Aldington and Mersham Support Group Submission for Deadline 4 (11th March 2025)

In this submission we have highlighted those issues that we don't believe have been satisfactorily addressed by the Applicant to date.

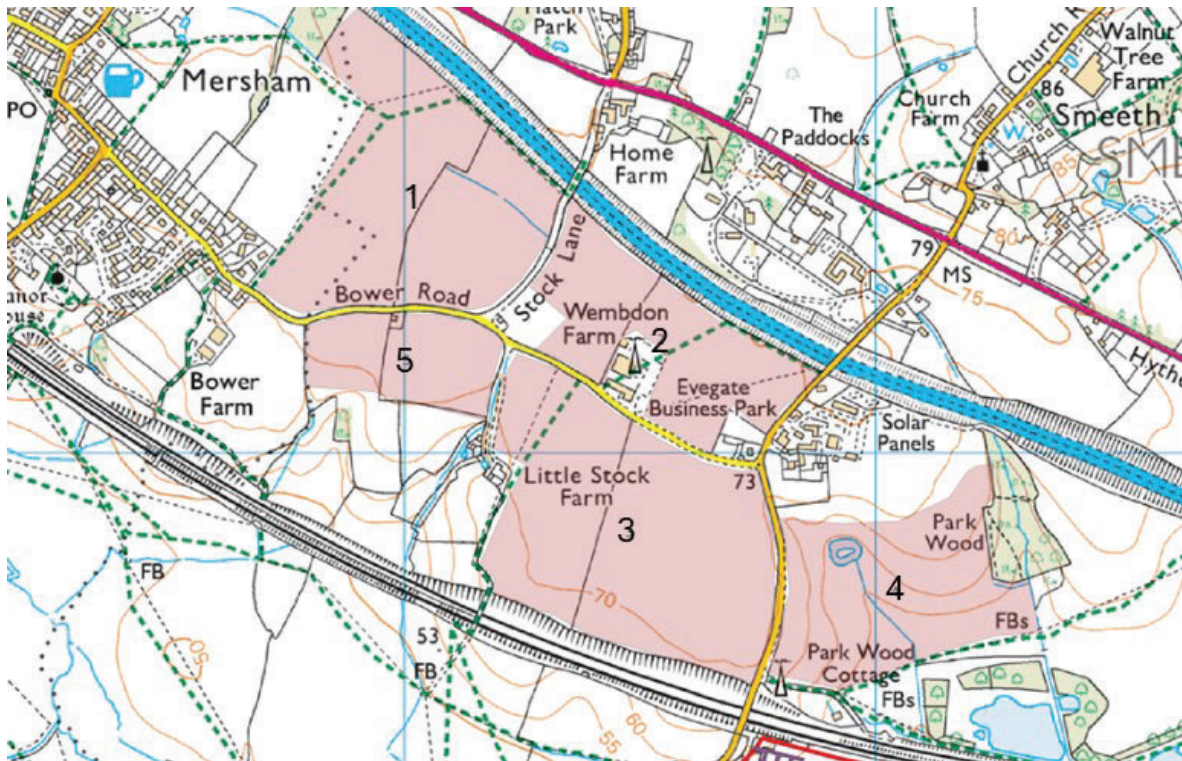
- Based on our own investigations we do not believe that the land shown shaded pink on the plan below has been properly investigated as a potential alternative to those parts of the submitted scheme which are incapable of adequate mitigation.

- Areas 1 and 5 on the plan are owned by [REDACTED] and we have asked his agent whether any approach was ever made by the Applicant regarding the possibility of acquiring a long lease for solar panels on this land and the agent confirmed that no such contact was made.

- Areas 2, 3, and 4 are owned by [REDACTED] and we have asked him whether any approach was made to him by the Applicant regarding the possibility of acquiring a long lease for solar panels on his land. He told us that he was approached by the Applicant regarding Area 4 – north of Park Wood Cottage (an approach which he declined) but he has never been approached by the Applicant in respect of areas 2 and 3.

- The pink land on the plan stands out as being worthy of consideration. It has no alternative land-use allocation, better and safer access (particularly for emergency services), it is flat throughout, has fewer residential properties in proximity, soil quality is much like that found on Aldington Ridge and, with moderate targeted planting, this alternative area would create far less adverse visual impact.

- Nor is it acceptable for the Applicant to claim retrospectively (if it now does) some difficulty in achieving a cable connection to the Substation (just visible on the plan south of the railway bridge) from the pink land. Such issues should have appeared in the alternatives and design evolution section of the application, had it been seriously looked at, which we say, it was not.
